31 May 2023

Job No. 21-13556

Subject: **Addendum to the Report of Preliminary Geotechnical Investigation and Geologic Fault Investigation and Response to the City of San Diego Geotechnical Review**
Proposed Javaheri Residence
2072 Via Casa Alta
La Jolla, California

SLIDEINTERPRET 6.039	Project					JAVAHERI		SECTION A-A'				
	Analysis Description					GLOBAL SLOPE STABILITY						
	Drawn By		R.A.C.		Scale		1:1350		Company		G.E.I.	
	Date		7/22/2022 2:21:53 PM					File Name		JOB NO. 21-13556_S(A)_01.slim

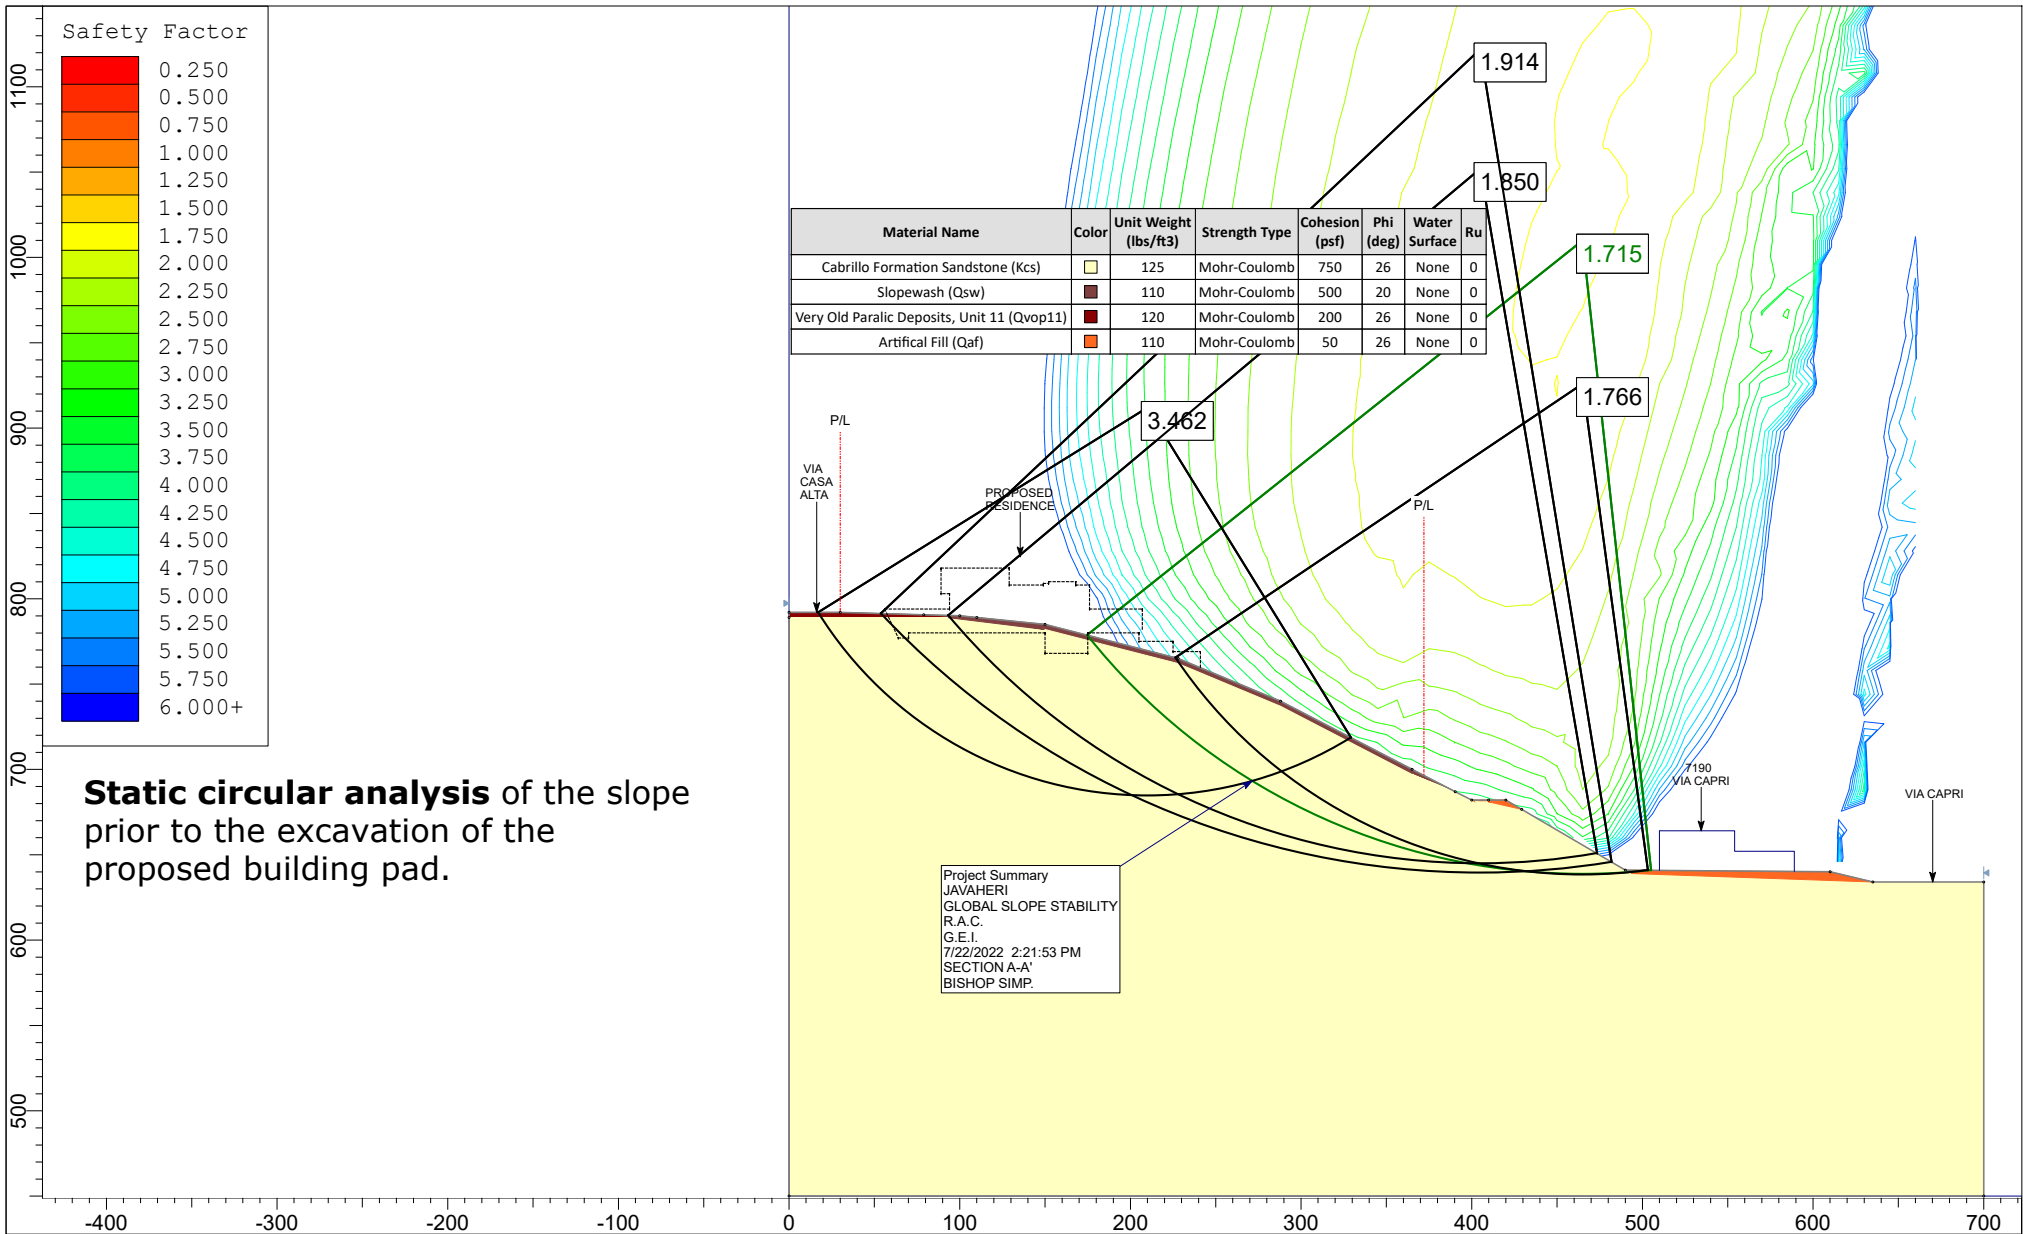
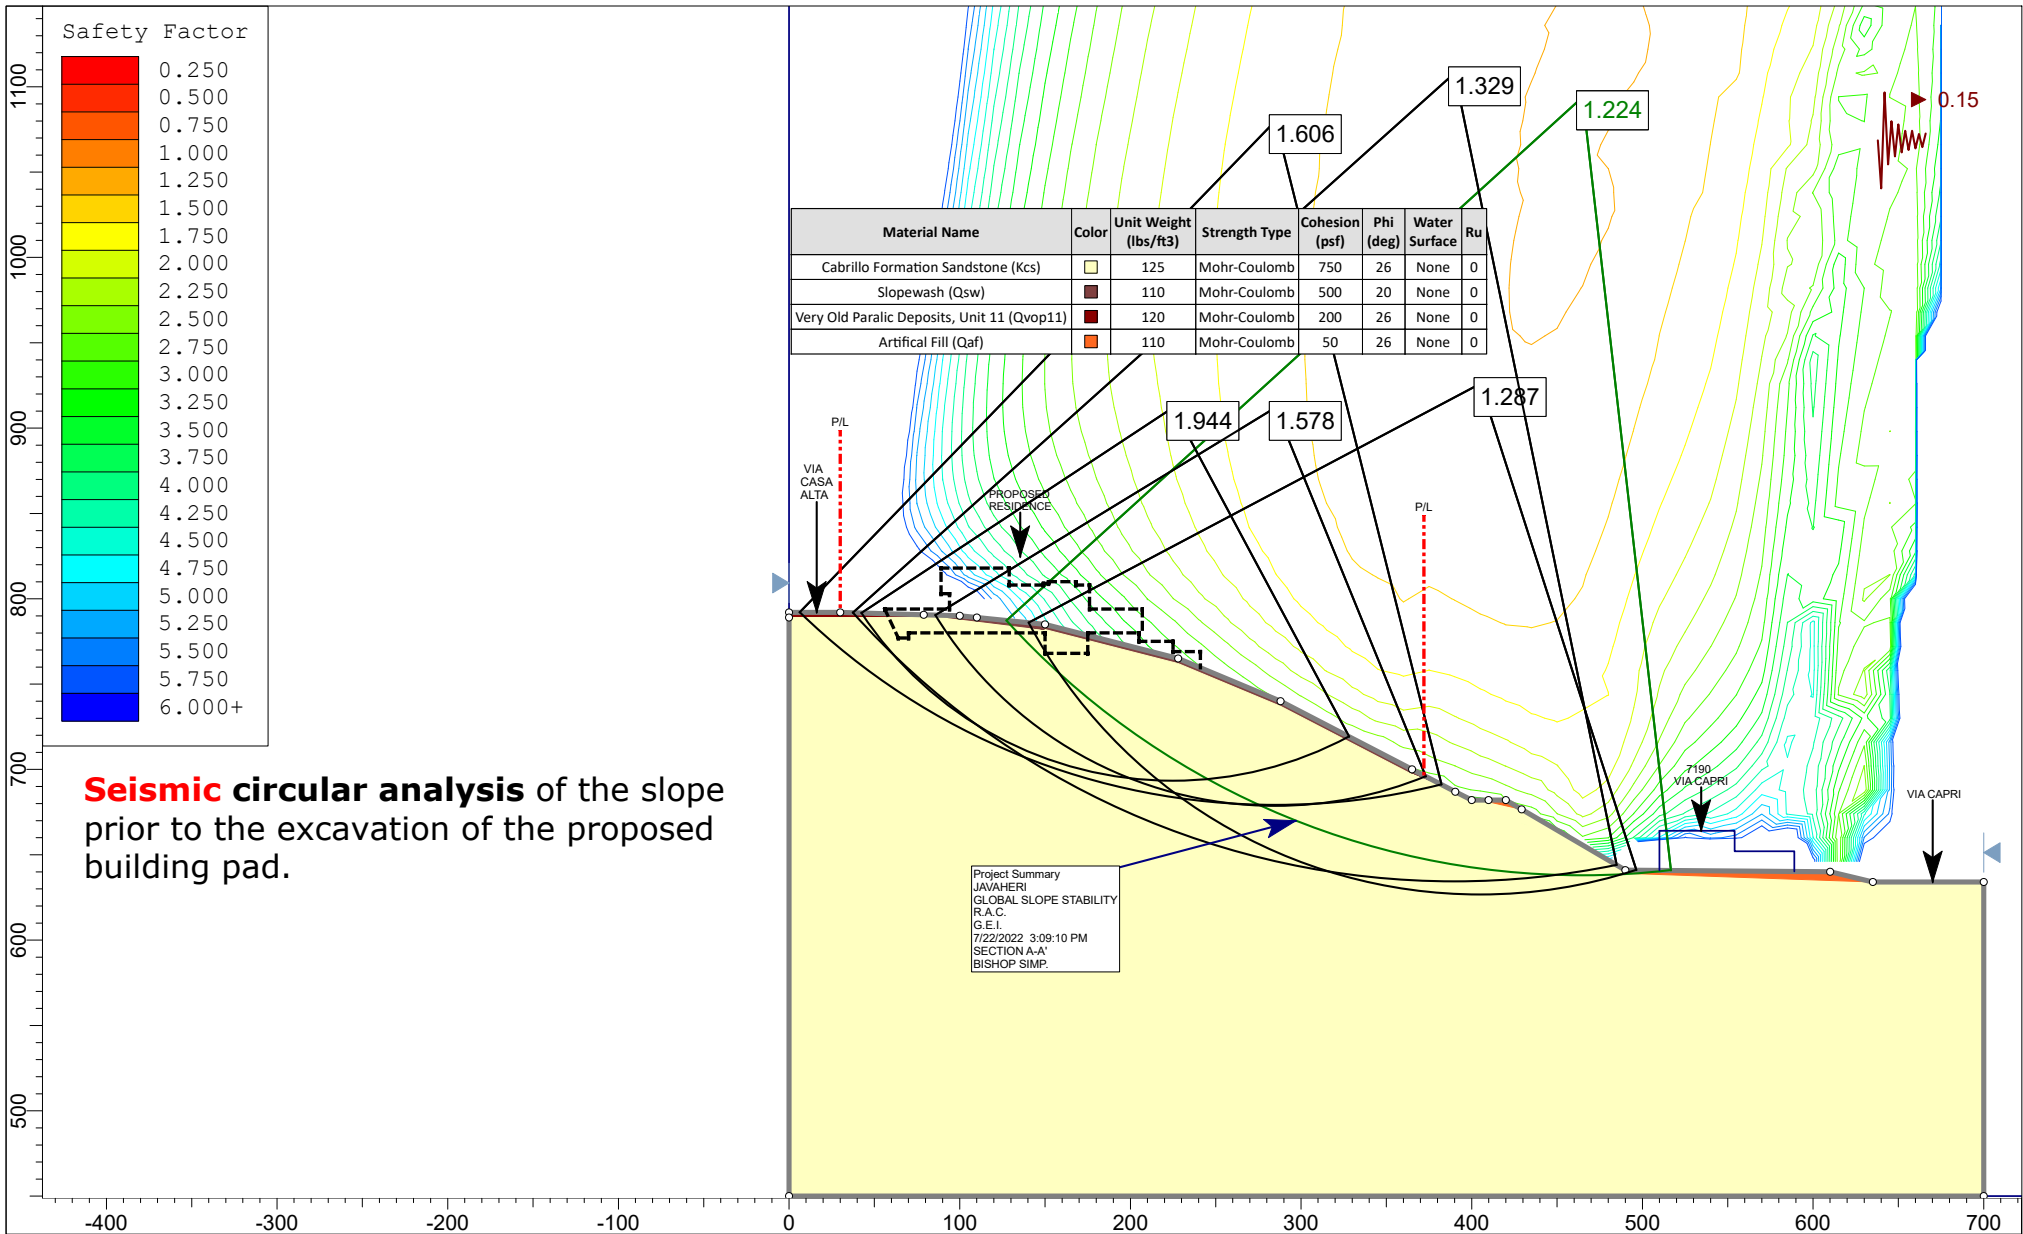
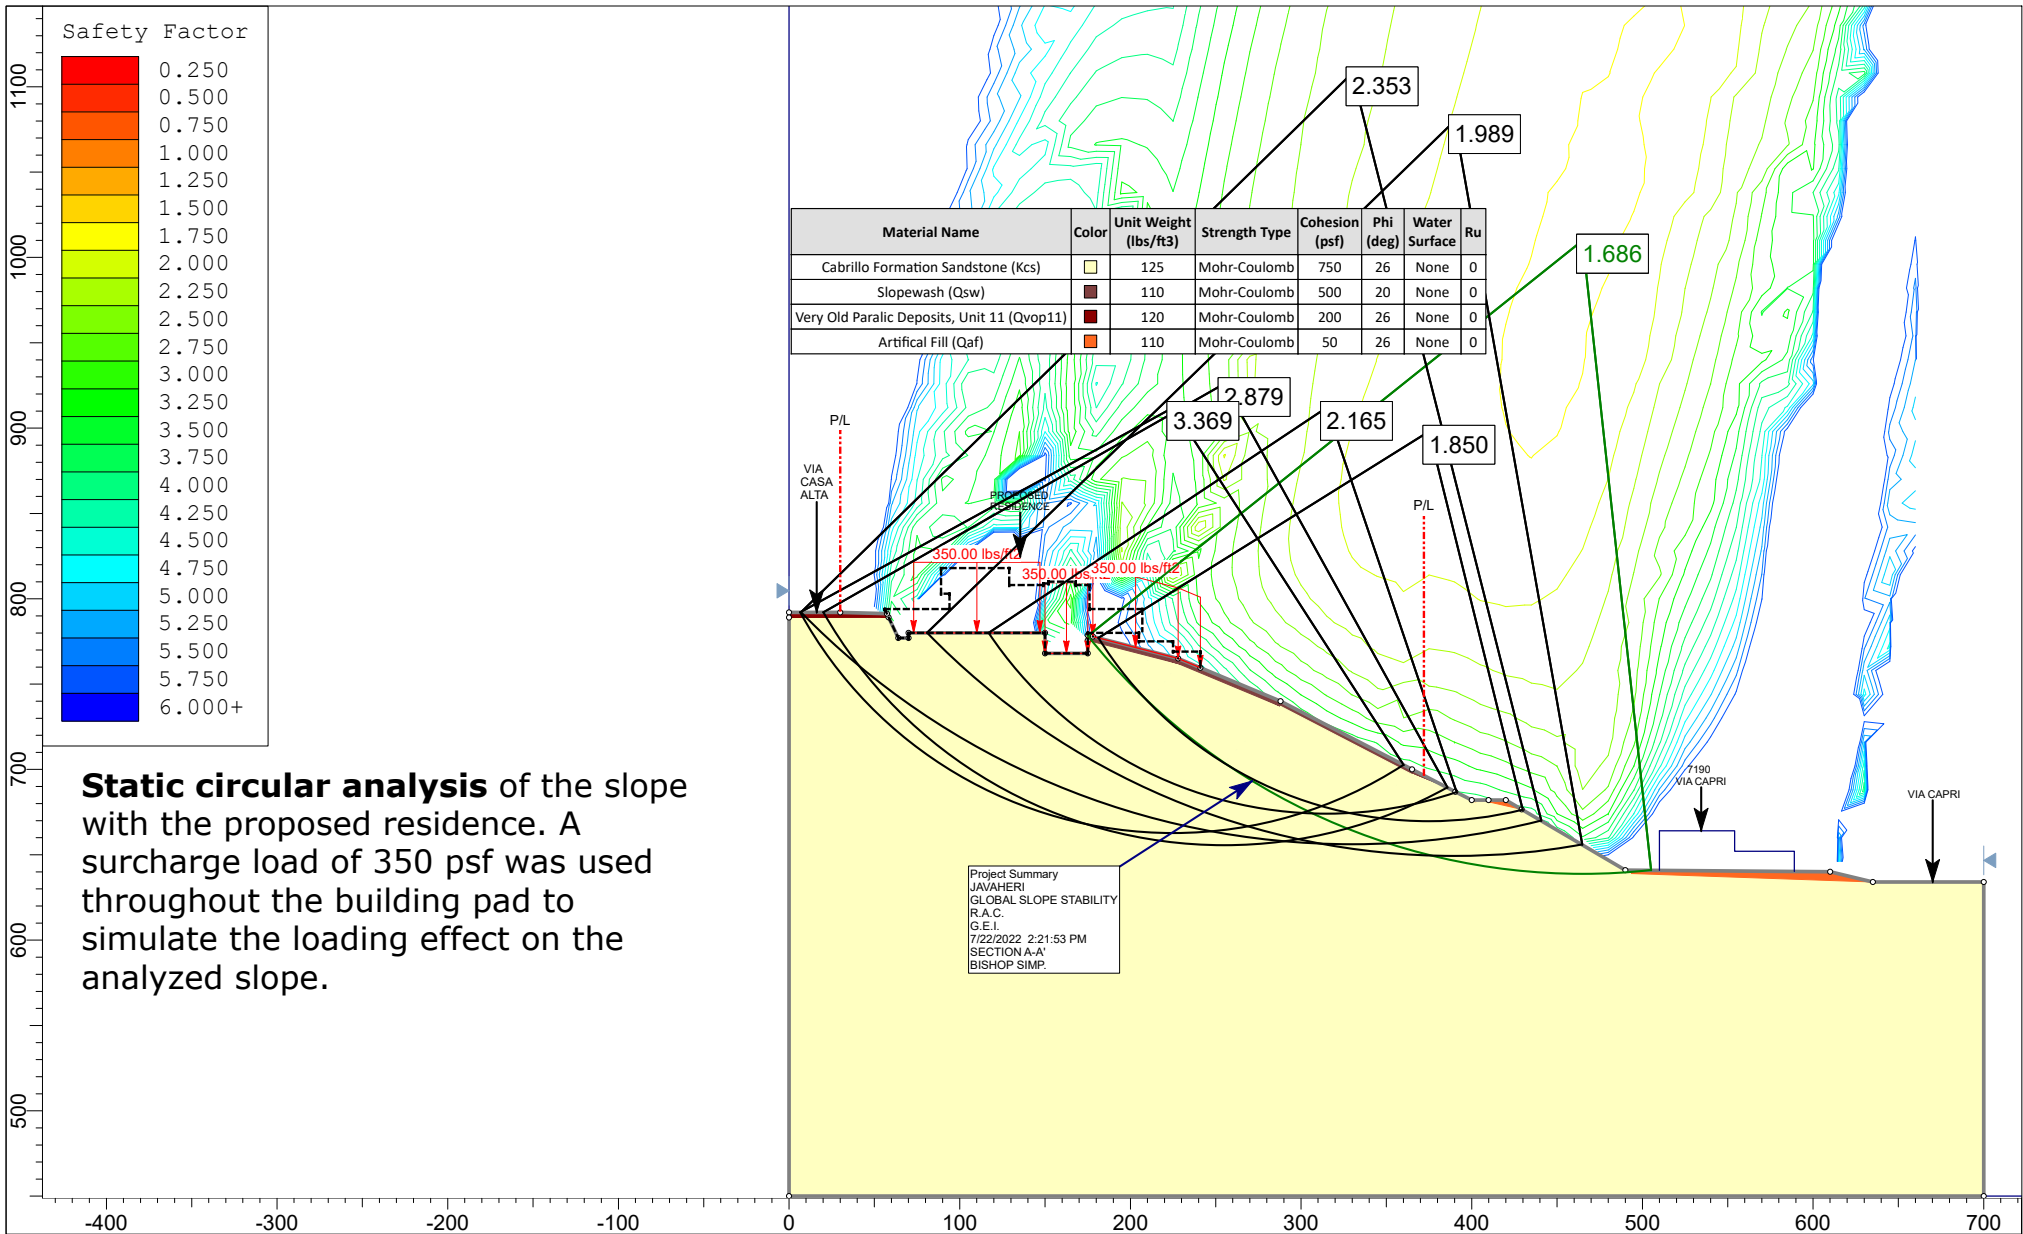
Issue No. 24: *The project's geotechnical consultant should clarify if their stability analysis presented in the submitted report included site-specific bedding and geologic structure data. As per the City's Guidelines for Geotechnical Reports, describe the stability analysis and discuss the results. The description should include the method of analysis, specified material profile, and specified search areas for critical failure paths. Where multiple slope stability analyses are conducted, a tabulated summary of the analyses and results should be provided. (New Issue)*

Response: The slope stability analysis, presented here as Appendix A, includes site-specific bedding and geologic structure data as well as the method of analysis, specified material profile, and specified search areas for critical failure paths. A tabulated summary of the analyses and results is also provided in Appendix A.

Analysis No.	Method-Type	Condition	Lowest FOS
S(A)_01	Bishop-Circular	Static	1.715
S(A)_01w_0.15g	Bishop-Circular	Seismic	1.224
S(A)_02	Bishop-Circular	Static	1.686
S(A)_02w_0.15g	Bishop-Circular	Seismic	1.215
S(A)_03	Spencer-Block	Static	1.748
S(A)_03w_0.15g	Spencer-Block	Seismic	1.171
S(A)_04	Spencer-Block	Static	1.781
S(A)_04w_0.15g	Spencer-Block	Seismic	1.279
S(A)_05	Spencer-Block	Static	1.842
S(A)_05w_0.15g	Spencer-Block	Seismic	1.295
